Report of Dam Safety Assessment of Coal Combustion
Surface Impoundments
NRG Energy
Huntley Generating Station
Tonawanda, NY

AMEC Project No. 3-2106-0194

September 2011

**ATTACHMENT 3
SLOPE STABILITY MODEL ANALYSIS**

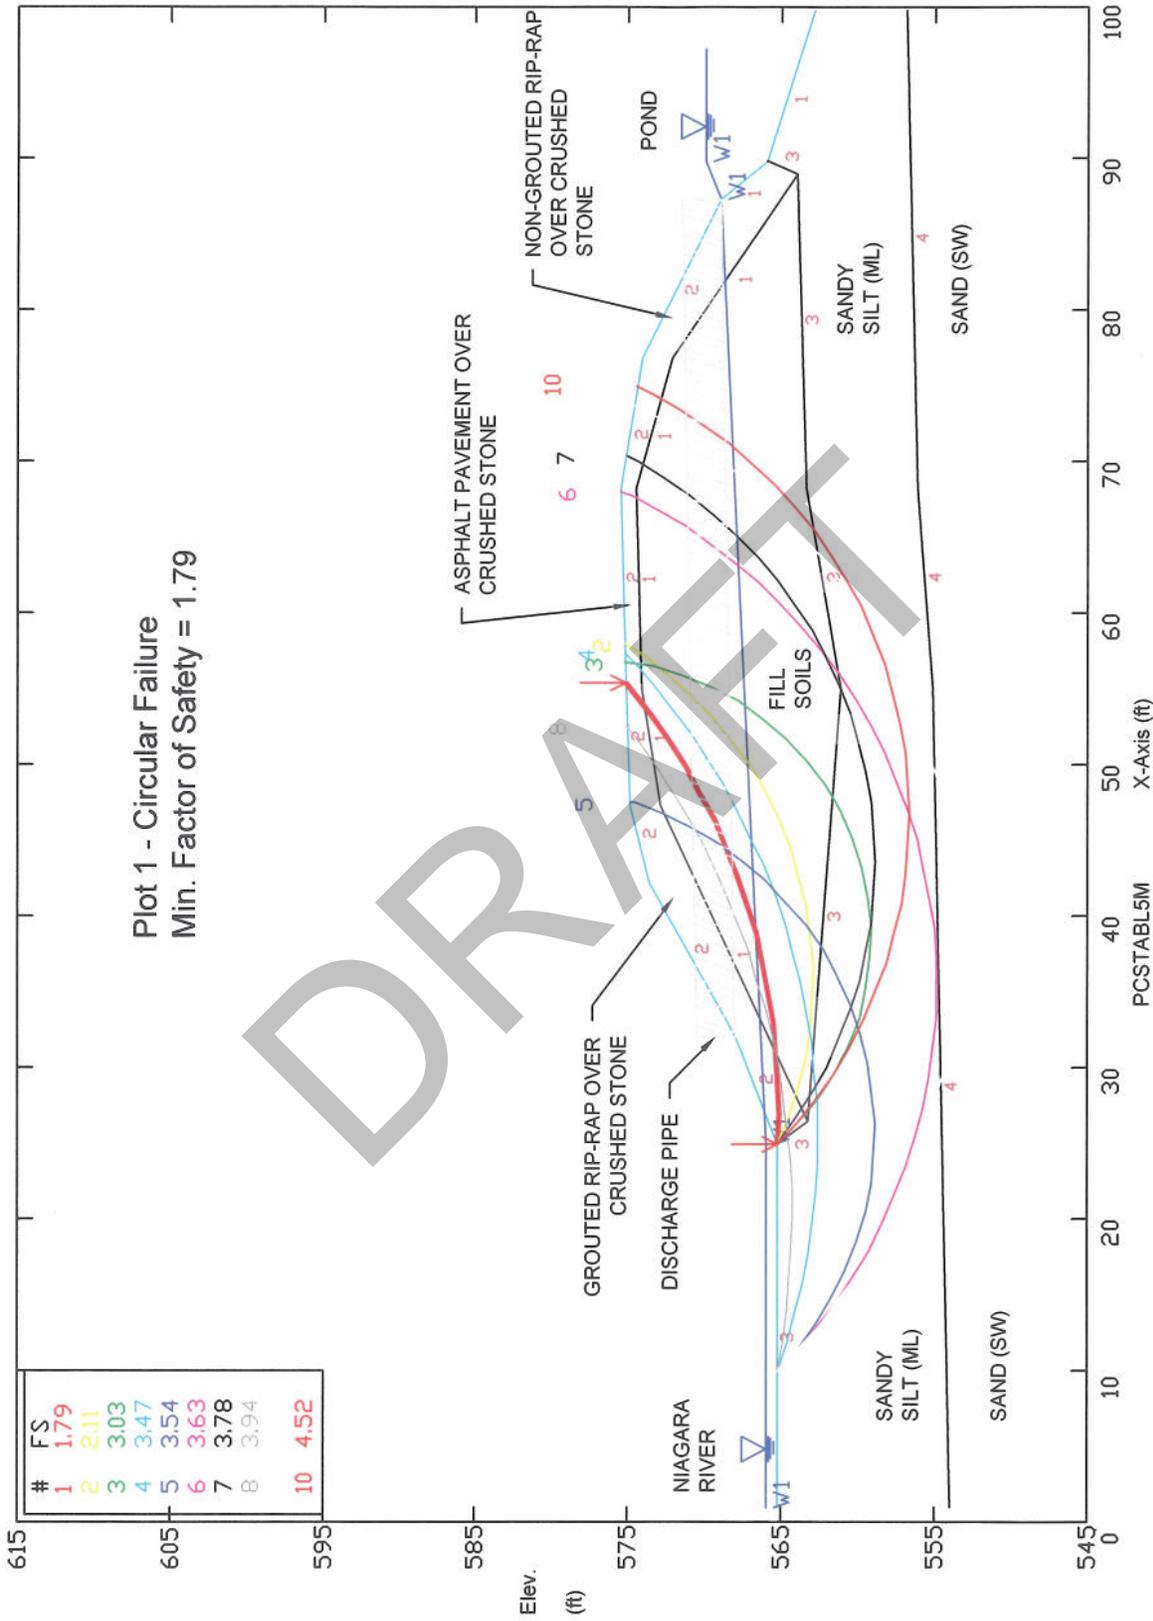
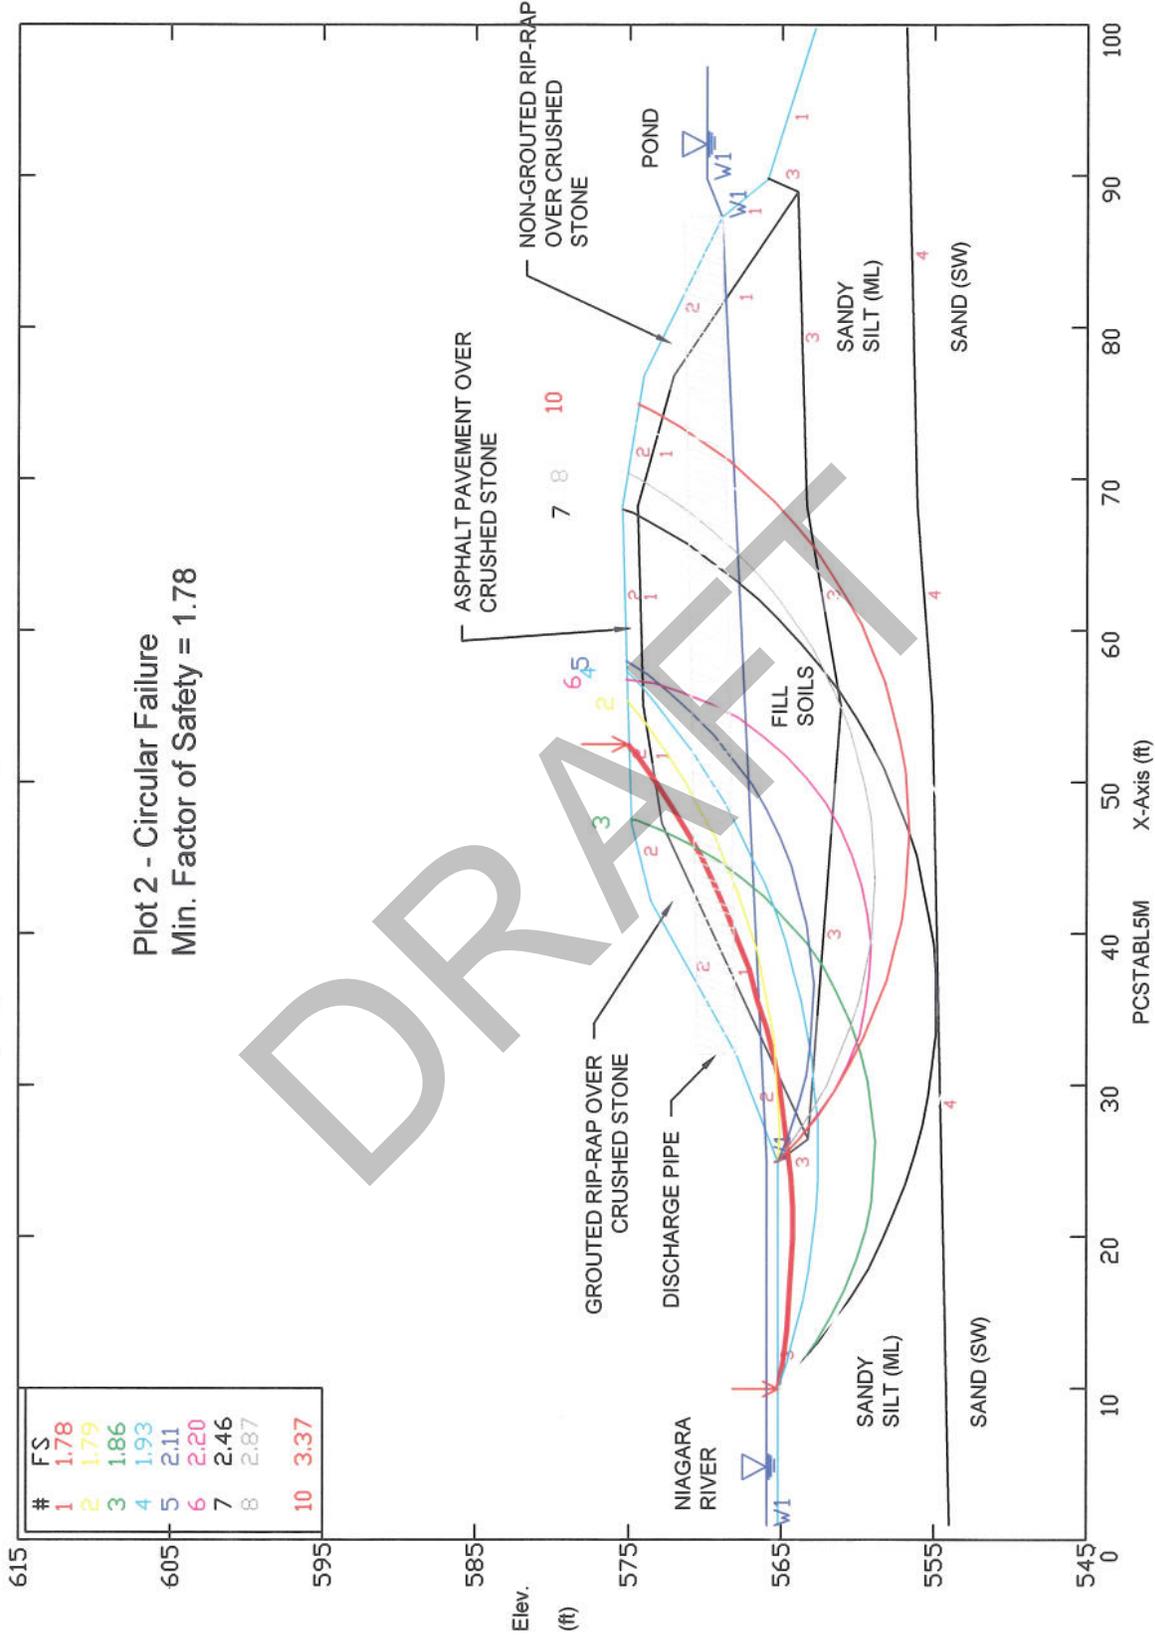
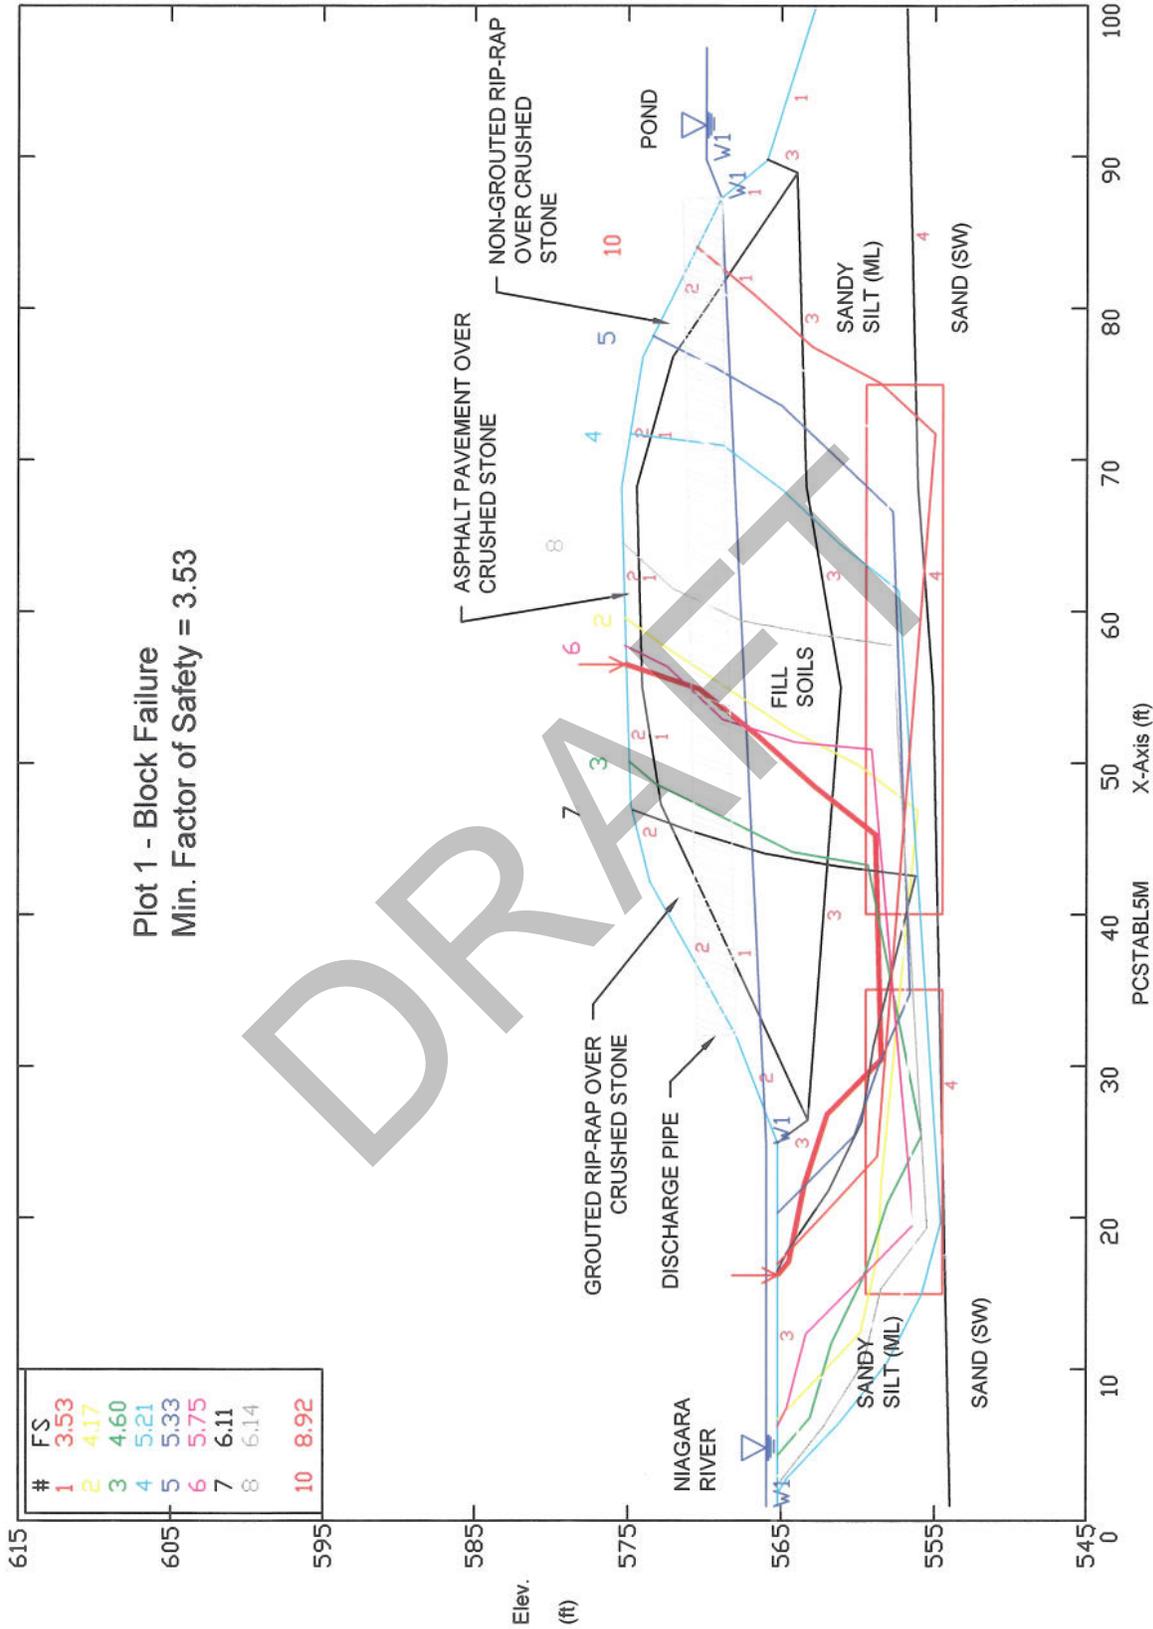
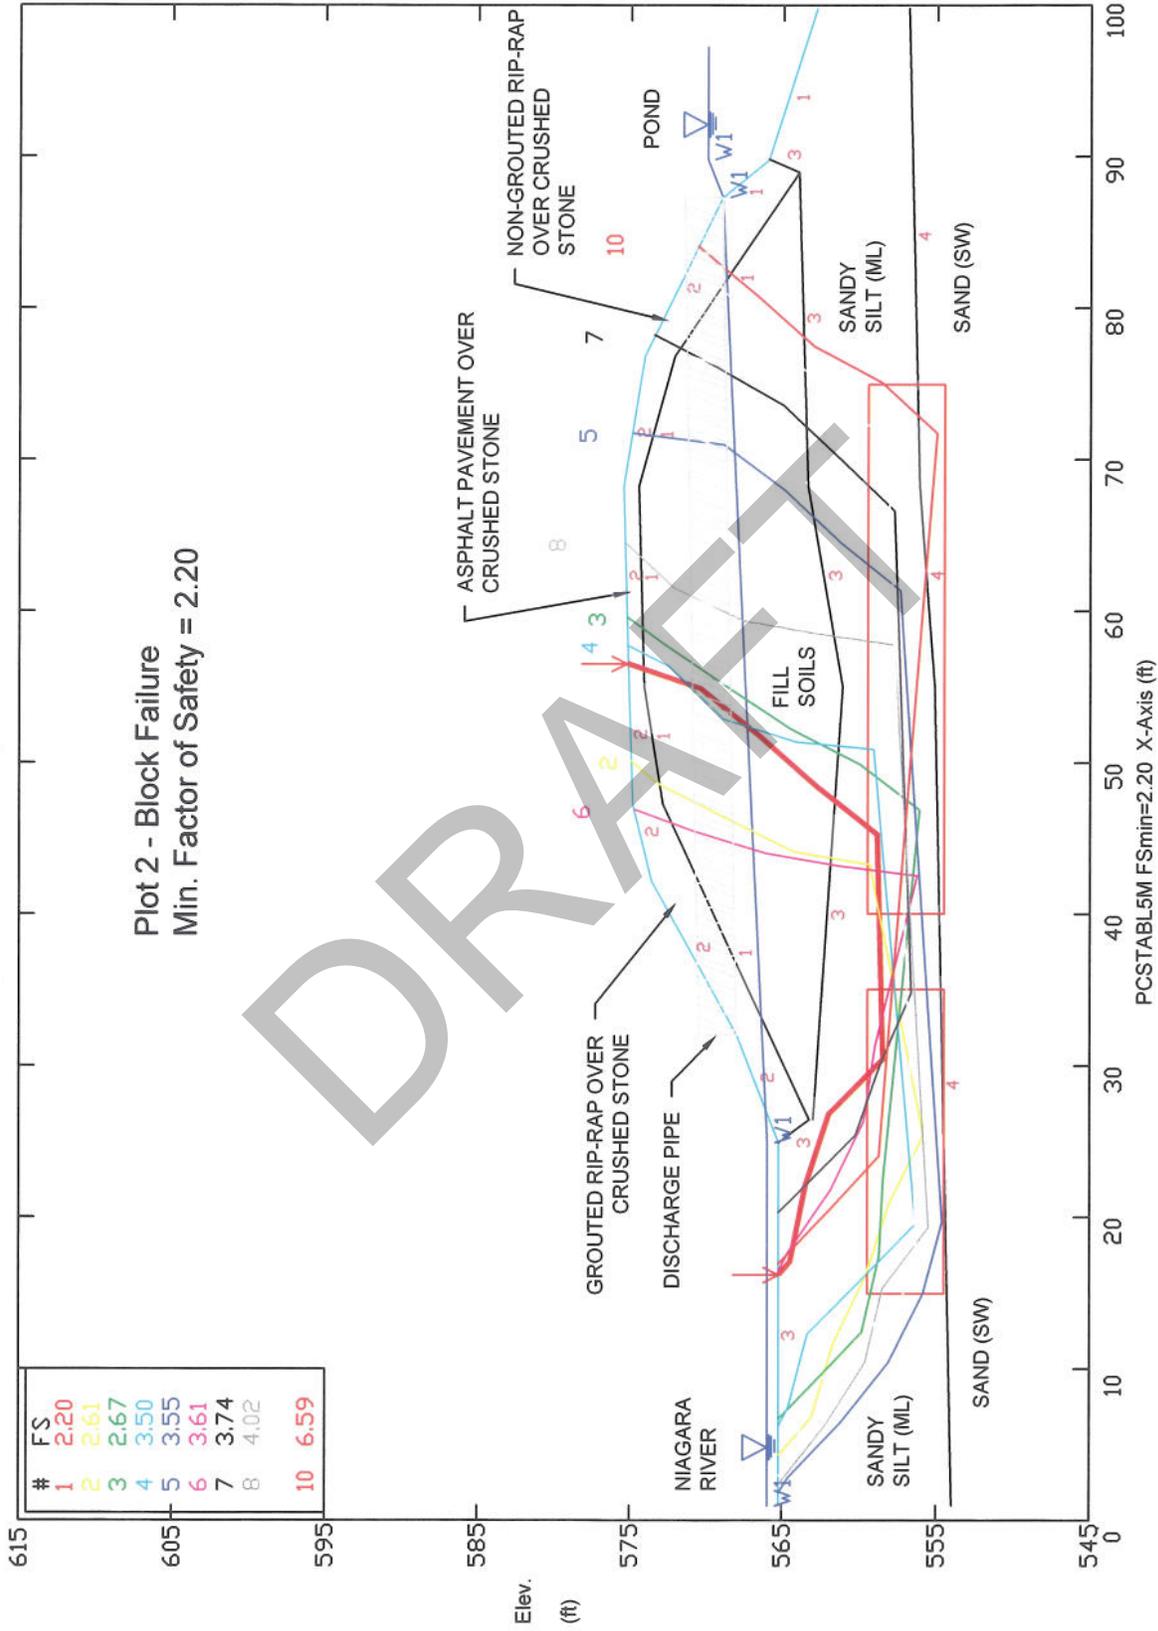
From the results of a triaxial test for the silt and fine sand layer, GZA presents two effective strength scenarios. AMEC agrees with the strength parameter of 0 psf for cohesion and 25 degrees for the internal friction angle (a 560 psf cohesion value is questionable for a non-plastic silt and sand). Based on this parameter and applicable analysis, the report provides a minimum factor of safety of 1.78 on a circular failure surface for the stability of the embankment. On review of the other soil strength parameters provided in the report, the friction angle used for the fill (30 degrees) may be high due to the presence of soft zones and debris noted in the boring. Using the Infinite Slope Analysis as presented in the report for a 3H:1V slope, a friction angle of 26 degrees corresponds to a factor of safety of 1.46, neglecting the additional slope stability provided by the surface rip-rap. Based on the Infinite Slope Analysis, it appears that the calculated factor of safety of the outlet embankment of the South Pond approximately meets the minimum required factor of safety from Table 6 .

Although the provided report comments on liquefaction due to seismic activity, a seismic stability analysis is not presented. AMEC recommends that the analysis be revised to include a seismic analysis. The analysis should be reviewed after completion of the recommended hydraulic study to evaluate elevated phreatic conditions and the need for a rapid drawdown analysis based on flood and receding waters of the Niagara River.
